Access Compliance Report

Public Rights-of-Way

Intersection ID: 4566	Main Street: LABORDE_AV	Cross Street: HOLLYWOOD_ST	Location: N
ADA ID: C4683210780E	Ramp Type: PerpDiag	Initial Pass/Fail: Fail	Overall Compliance: No
Codes/Mitigation Info/Possible Solution		Field Measurements/Component Compliance

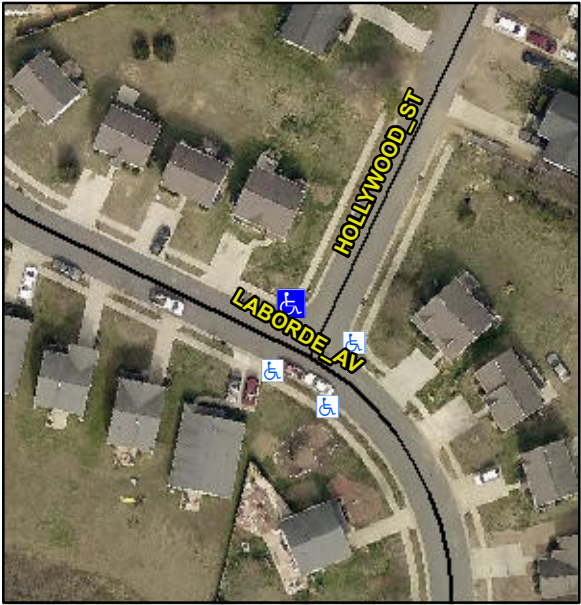
Possible Solutions:	Compliance	Description	Data	Compliance	Description	Data
	Remove & Replace Curb Ramp With Two New Directional Ramps or Equivalent.	N/A	Ramp Length (in)	48.0	No	Ramp Slope (%)	12.2
Surveyor Notes: N/A PROW/ADA: Not Found, R304.5.1, R304.2.2		No	Ramp Width (in)	40.5	Yes	Ramp XSlope (%)	0.7
		N/A	Flare Type LT	N/A	N/A	Flare Type RT	N/A
		N/A	Flare Slope LT (%)	N/A	N/A	Flare Slope RT (%)	N/A
		N/A	Flare Traversable LT?	N/A	N/A	Flare Traversable RT?	N/A
		N/A	Landing Length (in)	N/A	N/A	DWS Provided?	N/A
		N/A	Landing Width (in)	N/A	N/A	DWS Contrast?	N/A
		N/A	Landing Slope (%)	N/A	N/A	DWS Length (in)	N/A
		N/A	Landing X Slope (%)	N/A	N/A	DWS Full Width?	N/A
		N/A	Landing Curb? (Y/N)	N/A	N/A	DWS Offset (in)	N/A
		N/A	Shared Landing?	N/A			
		N/A	Gutter Ponding?	N/A	N/A	Gutter Slope (%)	N/A
		N/A	Gutter Lip Ht (in)	1.0	N/A	Gutter X Slope (%)	N/A
		N/A	Painted X Walk1?	No	N/A	Painted X Walk2?	No

X Walk 1 Direction	To S		X Walk 2 Direction	To SE
		N/A	X Walk 1 Width (in)	N/A	N/A	X Walk 2 Width (in)	N/A
			X Walk 1 Slope (%)	0.3		X Walk 2 Slope (%)	4.5
			X Walk 1 X Slope (%)	3.2		X Walk 2 X Slope (%)	3.1
		N/A	Ramp inside XWalk1?	N/A	N/A	Ramp inside XWalk2?	N/A
			Road Slope (%)	0.6	N/A	Clear Space?	N/A
			Road X Slope (%)	5.8	N/A	Clear Space to XWalk (in)	N/A
		N/A	Any Obstructions?	N/A	N/A	Storm Grate/Utility Hazard?	N/A
			Obstruction Type			Storm Grate/Utility Type	
					N/A		N/A
					Yes	Surface Condition? (G/P)	Good
Total Cost:		\$	3200.00
